**Economic Commission for Europe**
**Inland Transport Committee**
**World Forum for Harmonization of Vehicle Regulations**
**Working Party on Passive Safety**
**Seventy-second session**

**Report of the Working Party on Passive Safety  
 on its seventy-second session**
**Contents**

Amendments adopted to ECE/TRANS/WP.29/GRSP/2021/20 (see paragraph 11 of this report)

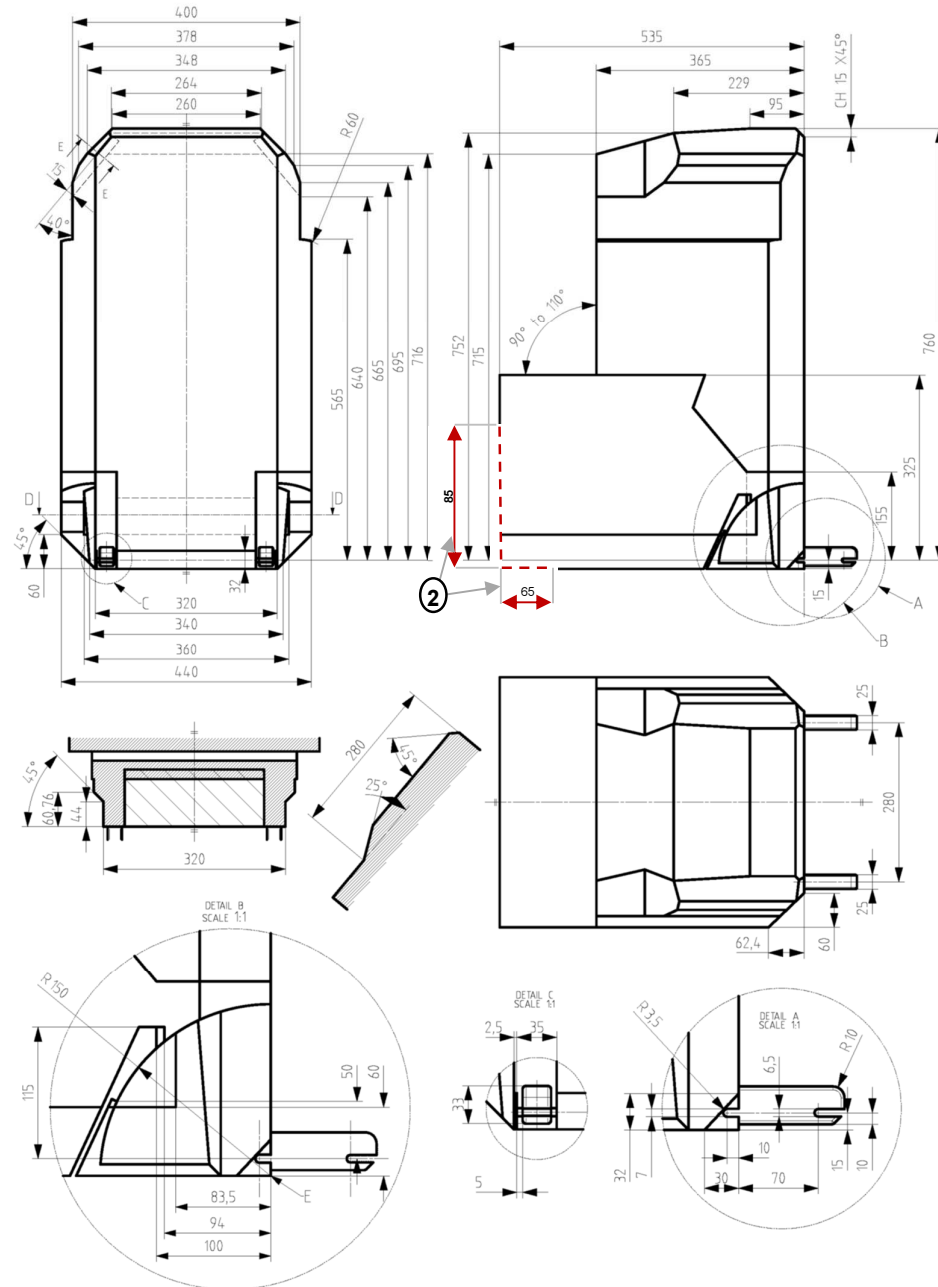
Annex 17 – Appendix 5, Figure 2, amend to read:

"Figure 1  
Side view of the support leg dimension assessment volume

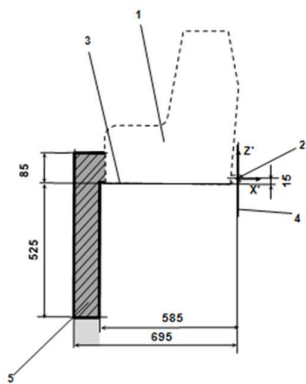
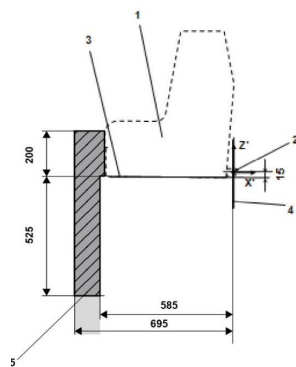
*Annex 19., Figure 1.*, amend to read:

"Figure 2  
3D view of the support leg dimension assessment volume

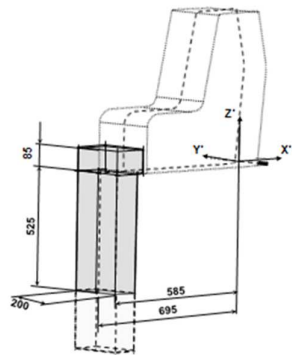
Annex 19., Figure 2, amend to read:
